## United States Patent and Trademark Office

Application No.	Applicant(s)				
Office Action Commons	10/617,941	GRETZ, THOMAS J.				
Office Action Summary	Examiner	Art Unit				
	Kofi A. Schulterbrandt	3632				
The MAILING DATE of this communication app Period for Reply	ears on the cover sheet with the	correspondence address				
A SHORTENED STATUTORY PERIOD FOR REPLY THE MAILING DATE OF THIS COMMUNICATION.  - Extensions of time may be available under the provisions of 37 CFR 1.13 after SIX (6) MONTHS from the mailing date of this communication.  - If the period for reply specified above is less than thirty (30) days, a reply - If NO period for reply is specified above, the maximum statutory period w - Failure to reply within the set or extended period for reply will, by statute, Any reply received by the Office later than three months after the mailing earned patent term adjustment. See 37 CFR 1.704(b).	36(a). In no event, however, may a reply be ti within the statutory minimum of thirty (30) da will apply and will expire SIX (6) MONTHS fror cause the application to become ABANDON	imely filed  ys will be considered timely.  n the mailing date of this communication.  ED (35 U.S.C. &

# CLAIM 4

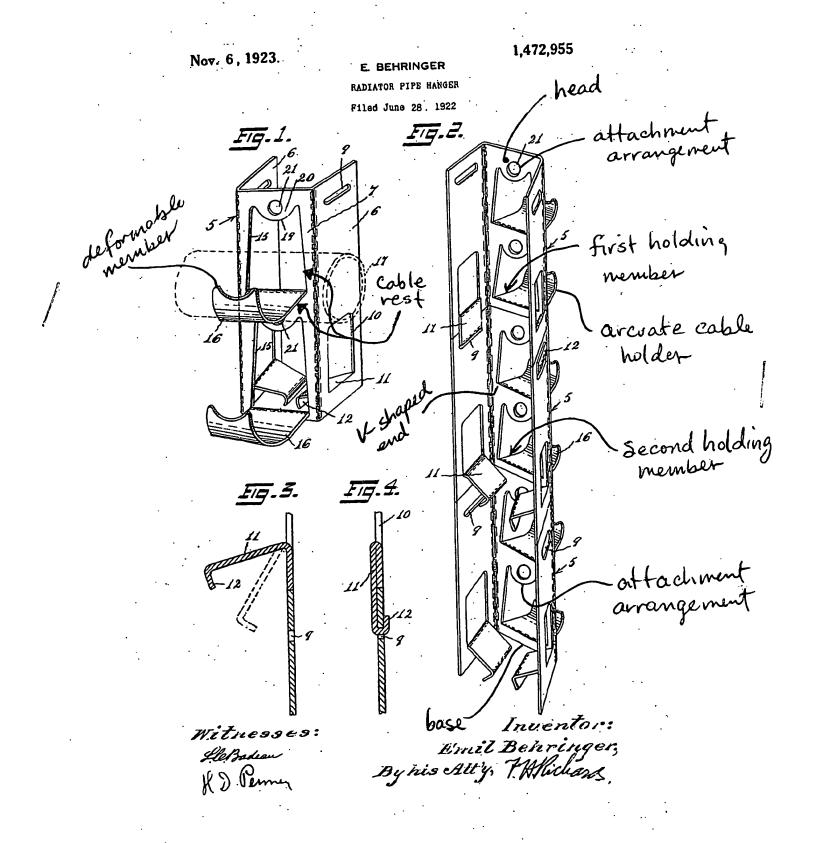
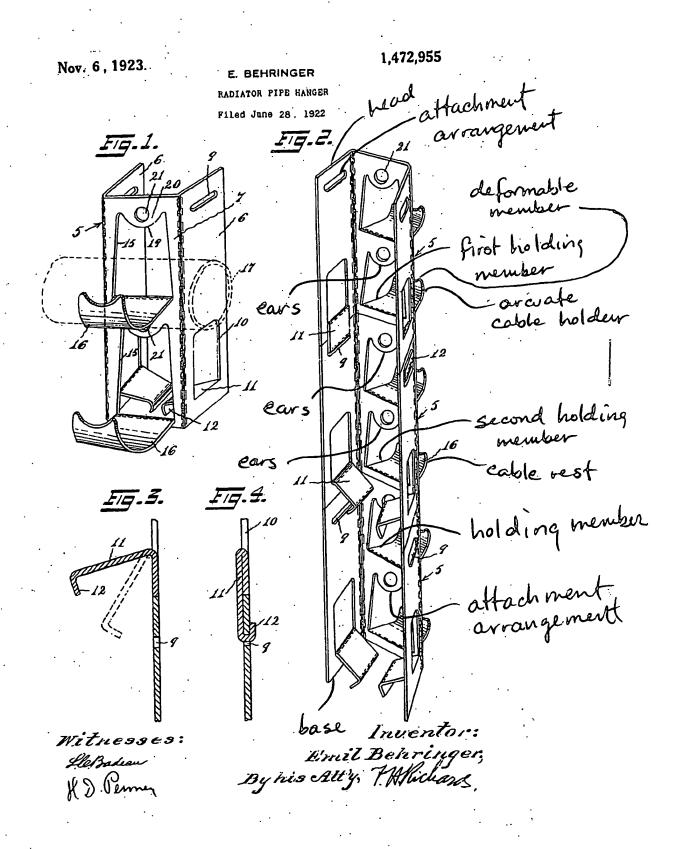
Regarding claim 1, the Applicant has not addressed the examiners interpretation of the reference. For example, the examiner provided and referred to marked-up drawings in the June 11, 2004 Office Action describing where the deformable member is located in Behringer. However, Applicant argues that Behringer's (11) is the deformable member. Behringer's (11) is a deformable member but not the deformable member chosen by the examiner. The Examiner's chosen deformable member clearly meets claim 1. Applicant should consider that the language "a deformable member that can be deformed" is extremely broad and could read on any member that could be deformed regardless of whether the text of the reference explicitly so teaches.

Applicant further argues that Behringer does not teach a second holding member. Again, applicant relies heavily on Behringer's text and does not address the examiner's reference interpretation to determine where Behringer's first and second holding members are located. In fact, even from a glance at the drawings, it is clear that element (16) of Figure 1 is a holder because it holds a cable. There are clearly numerous element (16)s. Regardless of what Behringer calls them in the text, each element 16, holds a cable and can be reasonably interpreted as a holder. Behringer, therefore, teaches at least a first and a second holder (16).
